City of Saco, ME
Planning Board Agenda
Tuesday, March 30, 2021 – 5:30PM
Regular Meeting & Public Hearings
Location: Remote via [Zoom.us](https://zoom.us)
All votes to be taken by roll call.

City of Saco, ME
Planning Board Meeting Minutes
Tuesday, March 2, 2021 – 6:00PM
Regular Meeting & Public Hearings
Location: Remote via Zoom.us
All votes taken by roll call.

PLOT PLAN, #66 OLD ORCHARD ROAD, SACO, MAINE
 MADE FOR MANN ENTERPRISE, INC. APRIL 13, 2020
 BY OWEN HASKELL, INC.

Drawing No.
C-7.5

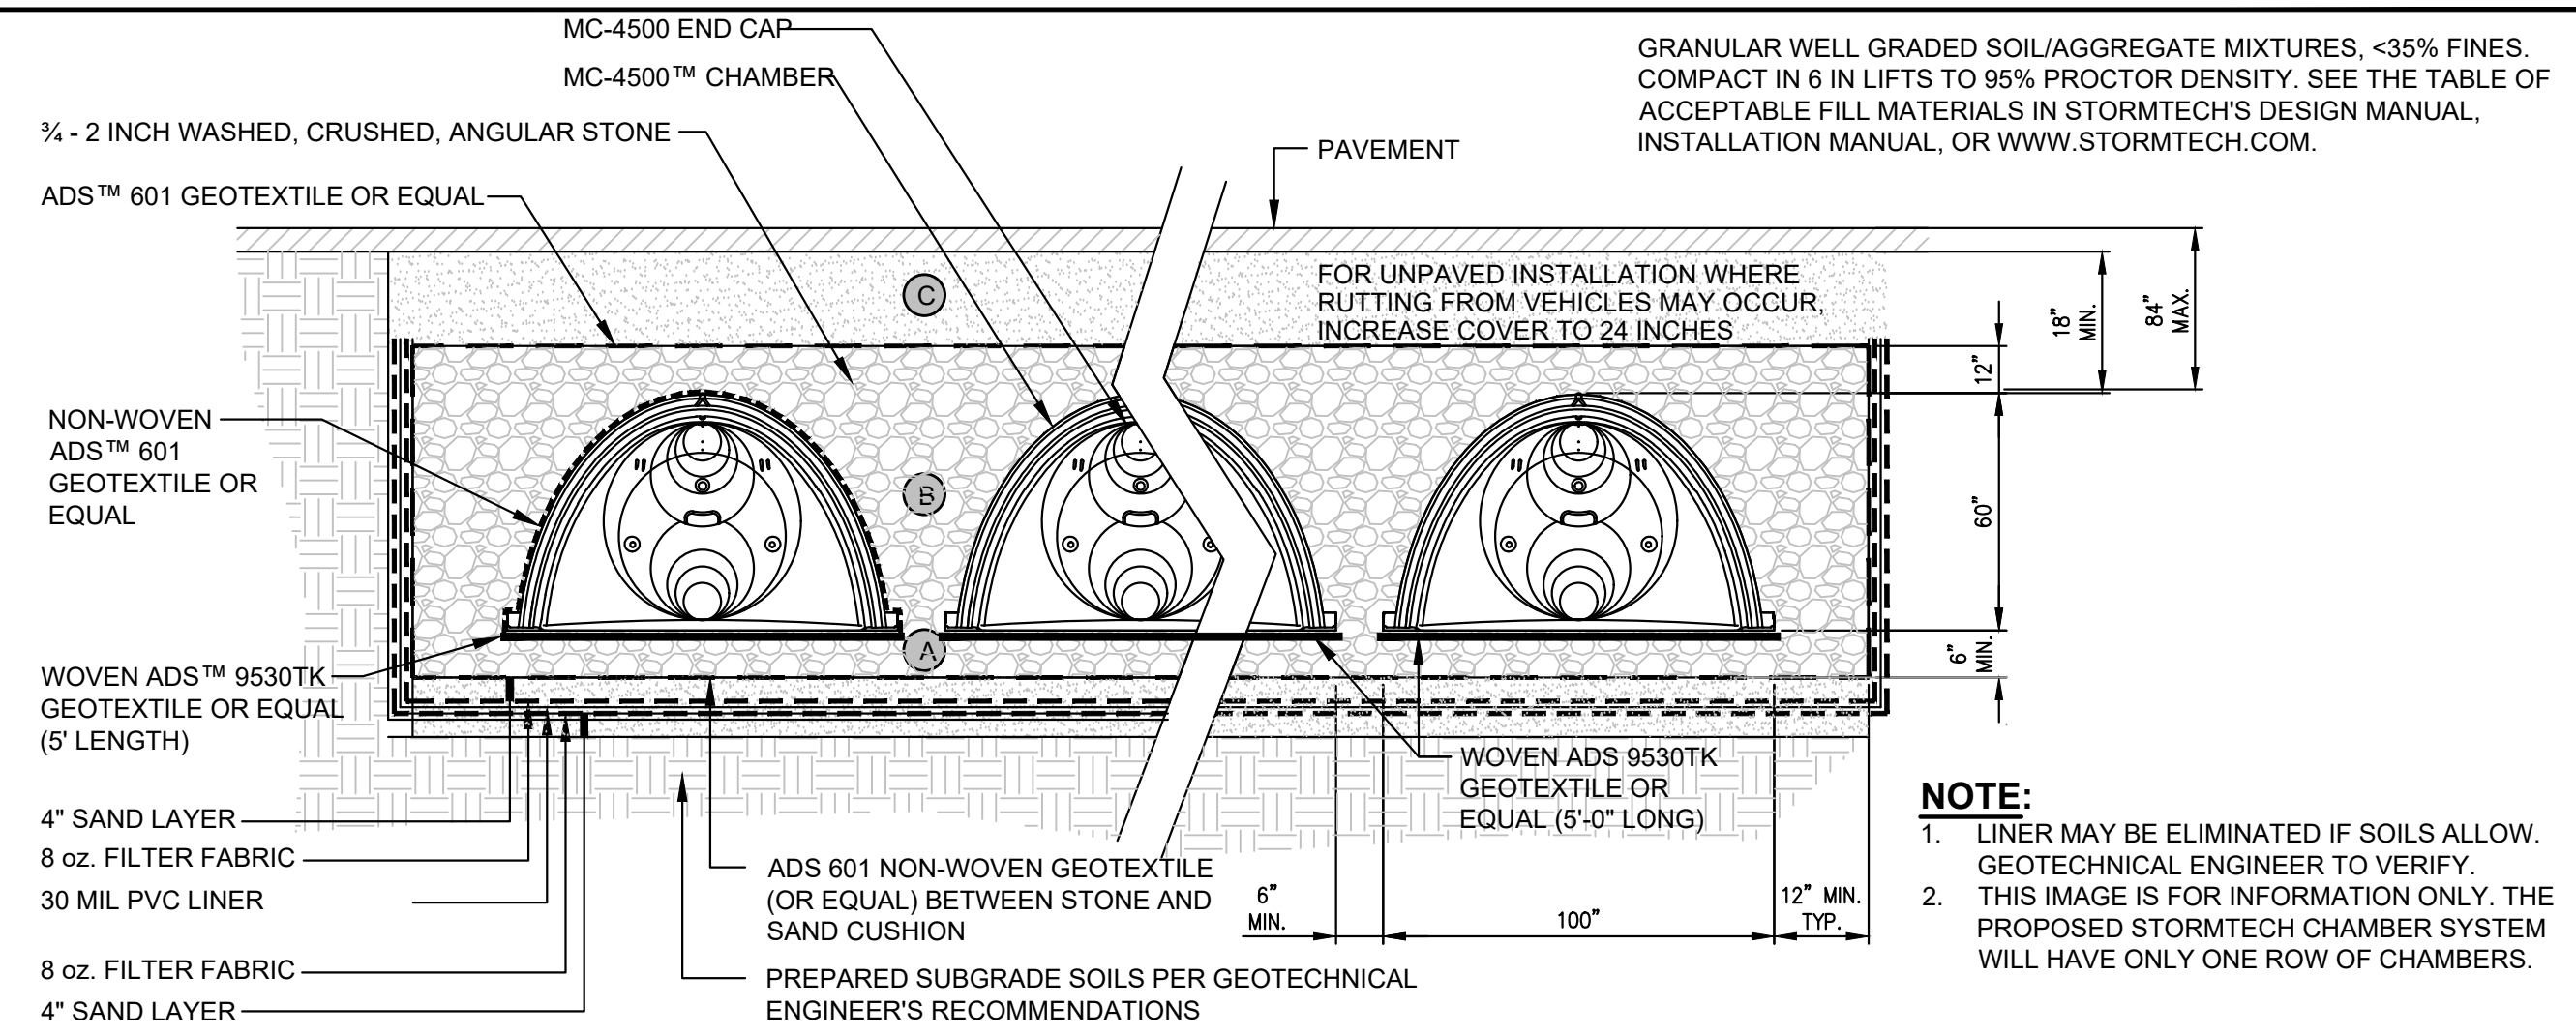
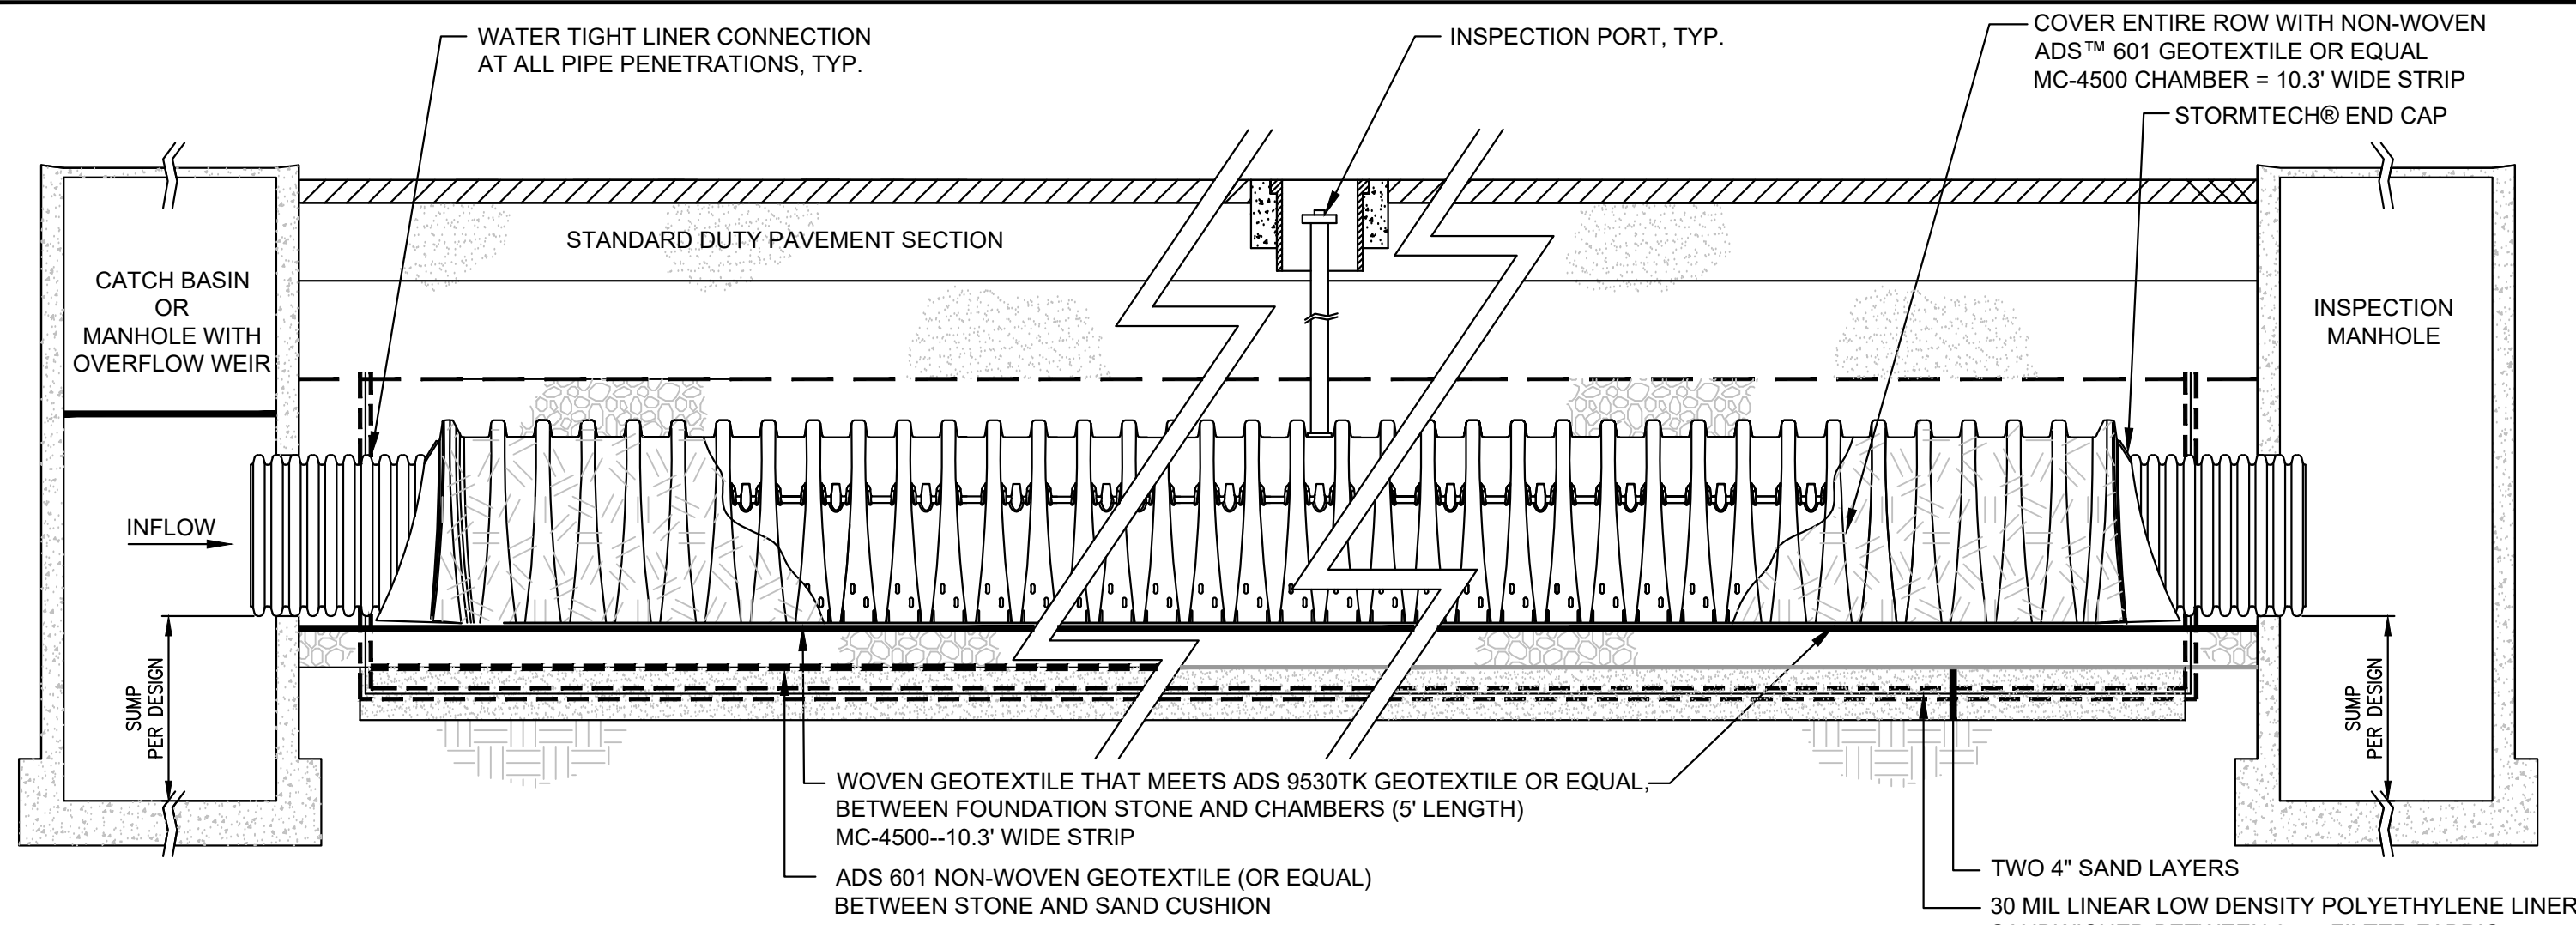
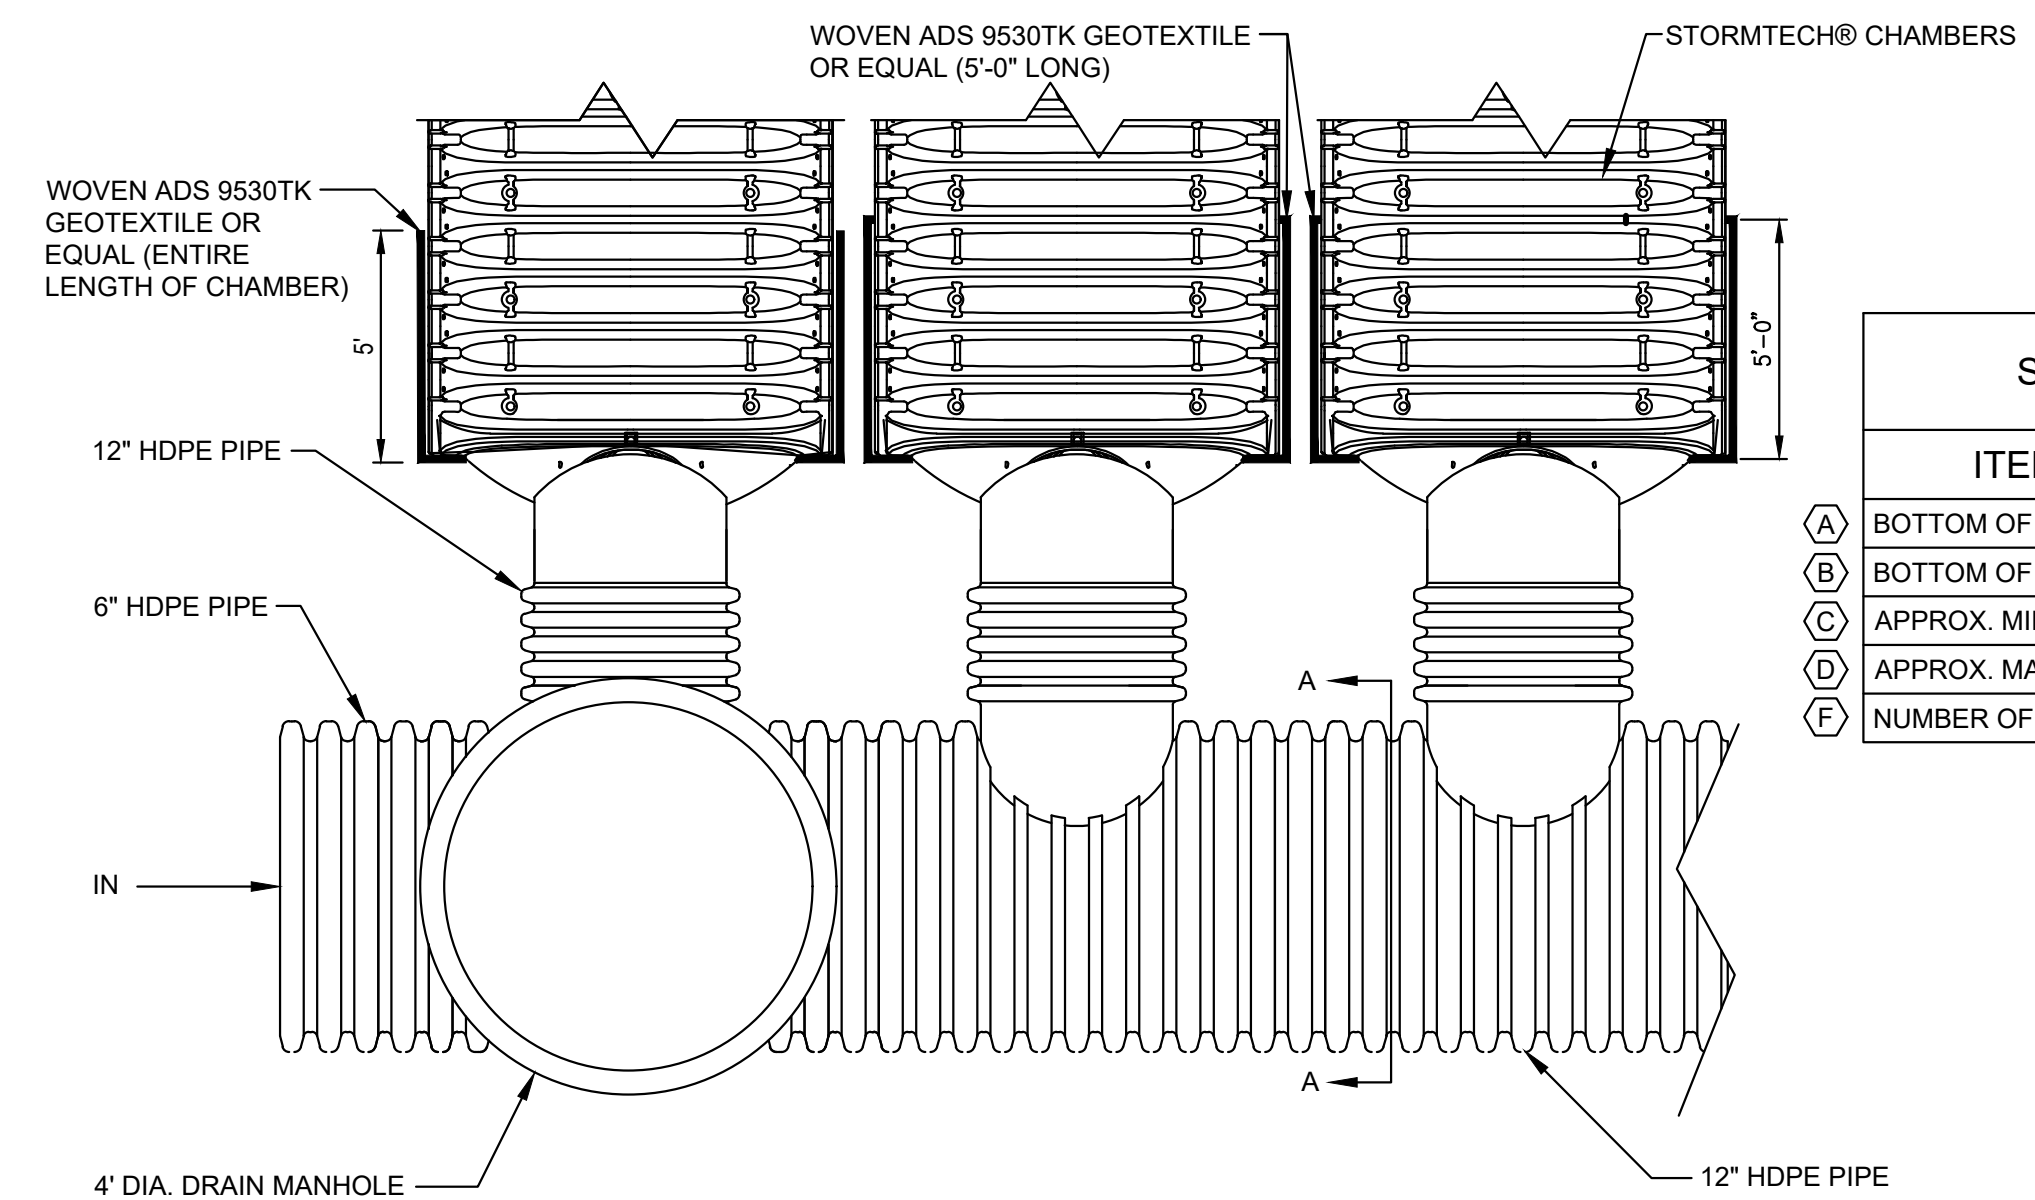
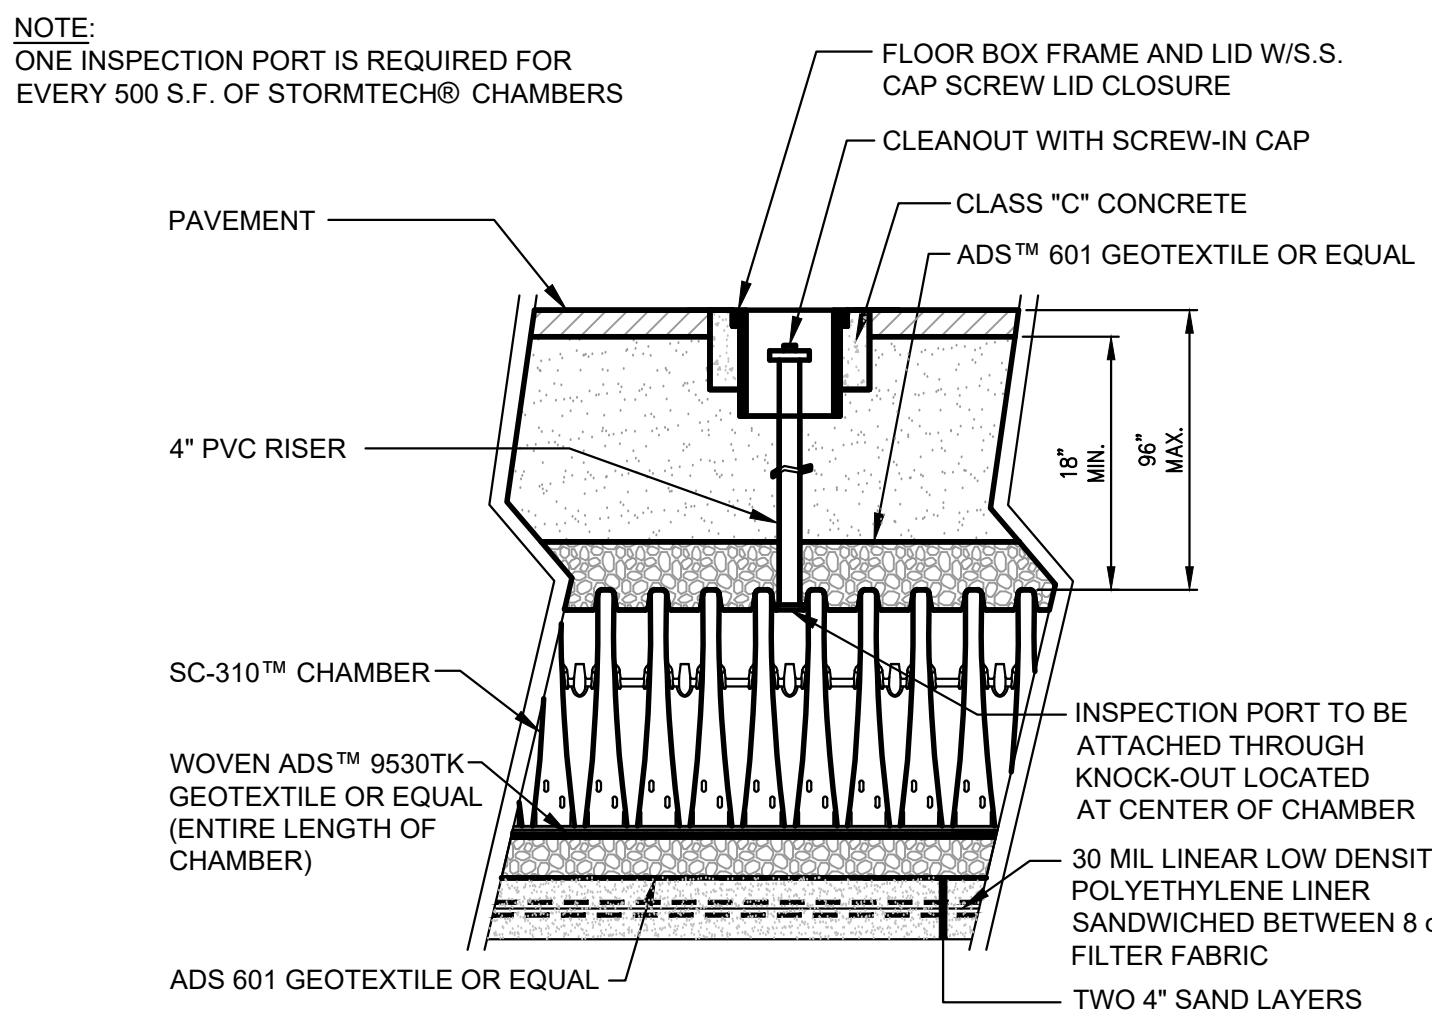
- How do Filterra units 1 and 2 outlet?*
- There are three drain manholes (3, 4 and 5) shown on the plans, but connecting storm drain lines are not shown.*
- Sheet C-7.5, the diameter of OCS-1 does not appear large enough to accommodate the pipes entering and exiting the structure. How will maintenance access be provided between the outlet pipe and internal weir structure.*
